DIGITAL 299 BROADBAND PROJECT

Addendum to Final Environmental Assessment and Initial Study/Mitigated Negative Declaration

April 2024

The location of the Proposed Modification is shown in **Figure 1**. The originally proposed alignment that follows Hammond Trail is shown in black on **Figure 1**).

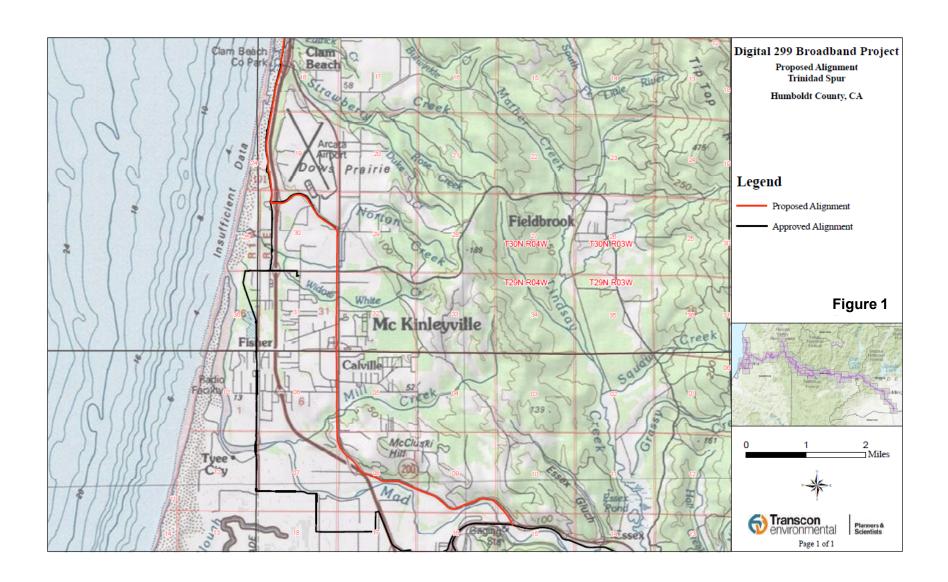
Section 2.21 Project Location and Areas of Disturbance of the EA/ISMND describes the project's action area across Humboldt, Trinity, and Shasta counties. At the northwestern end of the project, the EA/ISMND describes the primary route following local roads in Arcata and along the Hammond Trail. Instead, the Proponent proposes to reroute the alignment to the east, reducing the total mileage of fiber optic conduit by about 2 miles. The Proponent proposes to modify the alignment to head west along State Route (SR) 200 from the intersection with SR-299 to the intersection with Central Avenue, where the alignment will then head north to Airport Road. The

alignment will then head north along U.S. Route 101 until following an on-ramp at Clam Beach Drive, where construction will follow the previously studied alignment, which follows Clam Beach Drive, U.S. Route 101, and other local roads north to the City of Trinidad. This change in the alignment will help the State of California meet their MMBI goals by 2026 by providing future opportunities for last-mile tie-ins in downtown McKinleyville. Additionally, the alignment change will reduce the potential impacts to resources by staying in more developed areas along public right-of-way. Examples of reduced impacts include impacts to public recreation by avoiding construction on the Hammond Trail and impacts to aquatic resources by eliminating one crossing of the Mad River.
